RANCHO SANTIAGO COMMUNITY COLLEGE DISTRICT

ADDENDUM NO. 2

Bid #1497
Building B Restroom Modernization
at
Santiago Canyon College

Project ID #3780
DSA #04-124615

SCC Building B Restroom Modernization
Addendum # 1 - Revision to Mechanical Drawing Sheet M6.1

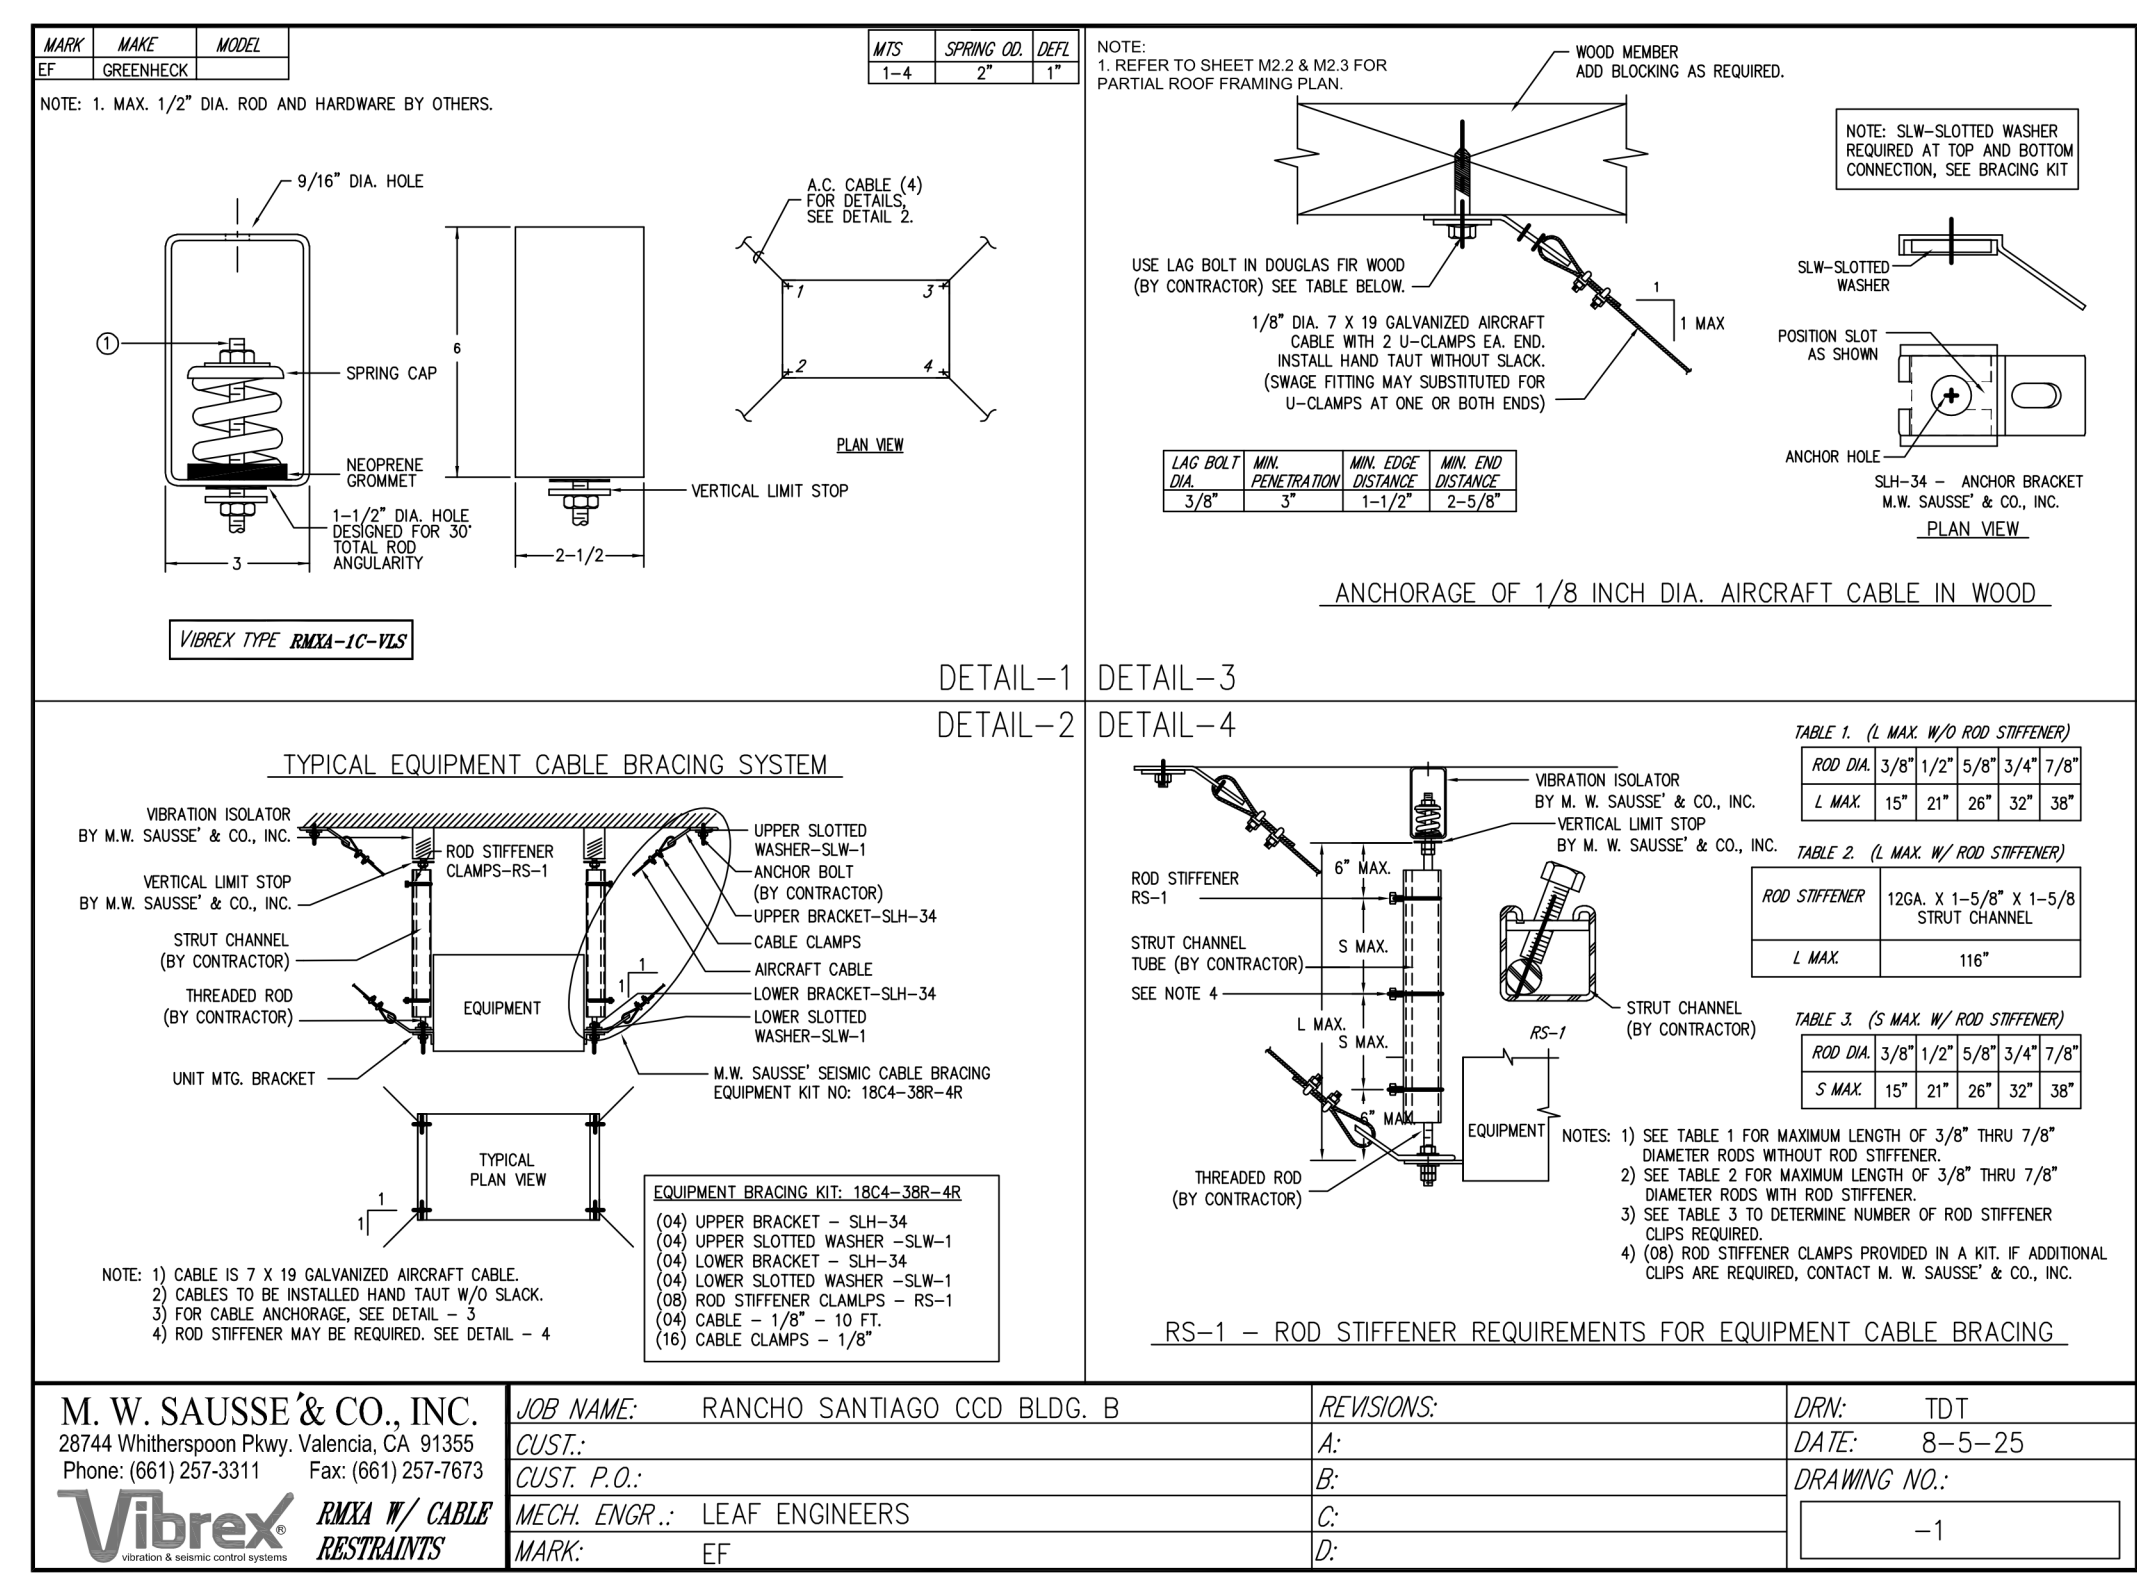
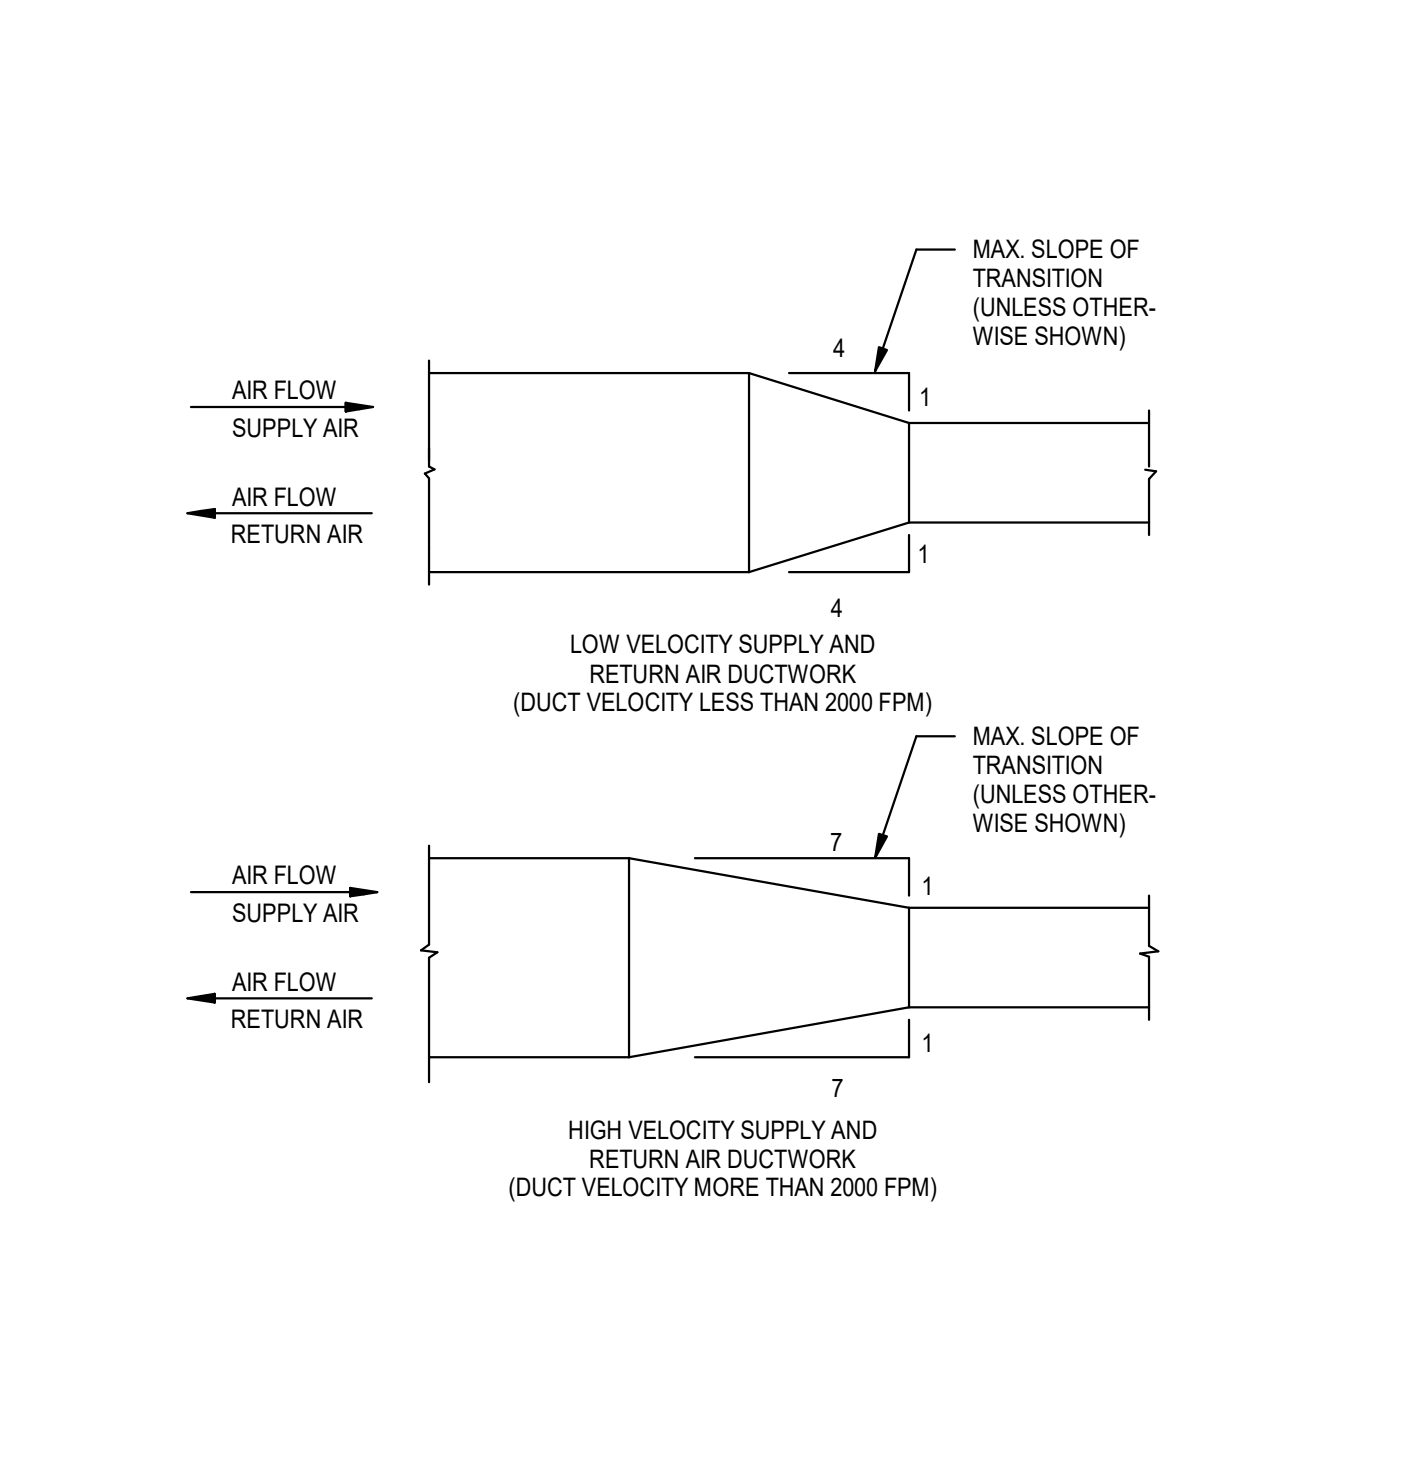
Item No. AD 2-3 Revision to Mechanical Drawings Sheet M6.1

Item No. 1.02 **Sheet M6.1:** Add Detail 7 for BAS ARCHITECTURE-CONTROL.
